MISSISSIPPI POWER & LIGHT COMPANY

January 18, 1983

SUBJECT: Grand Gulf Nuclear Station
Units 1 and 2
Docket Nos. 50-416 and 50-417
License No. NPF-13
File 0260/15180
Reference AECM-82/626
 AECM-83/012
Request for Additional
Information - Protective
Sleeves for LPRMs
AECM-83/32

Figure 2
Attachment 1

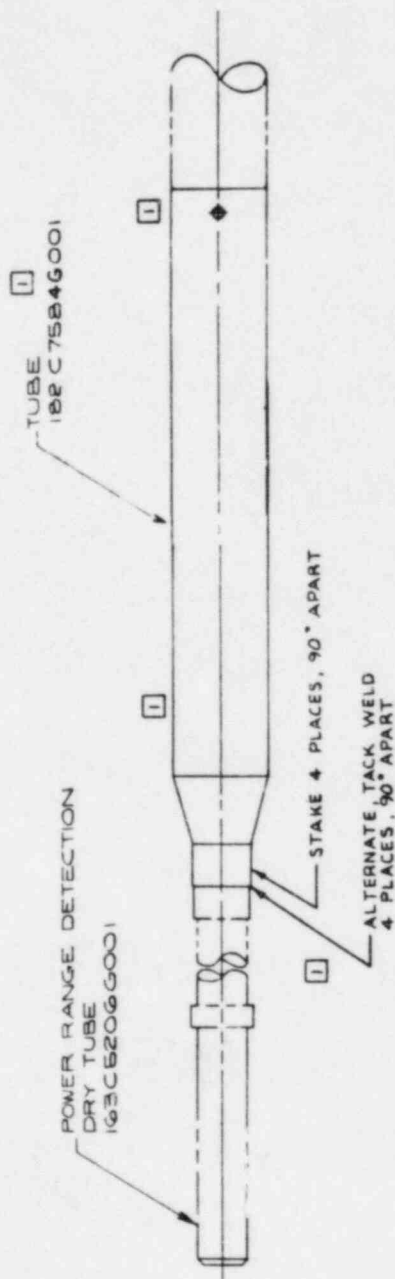
Provide drawings which present the hardware to be installed and location of attachment points.

The drawings showing the sleeve details and the LPRM at the point of attachment are listed below, and are provided as attached figures.

- Figure 1. Added sleeve - 188C7584, Tube
- Figure 2. Installation drawing - 188C7583, Plunger
- Figure 3. Point of attachment (ASM) - 262A7418, Spring Housing
- Figure 4. Point of attachment (detail) - 262A7417, Tube
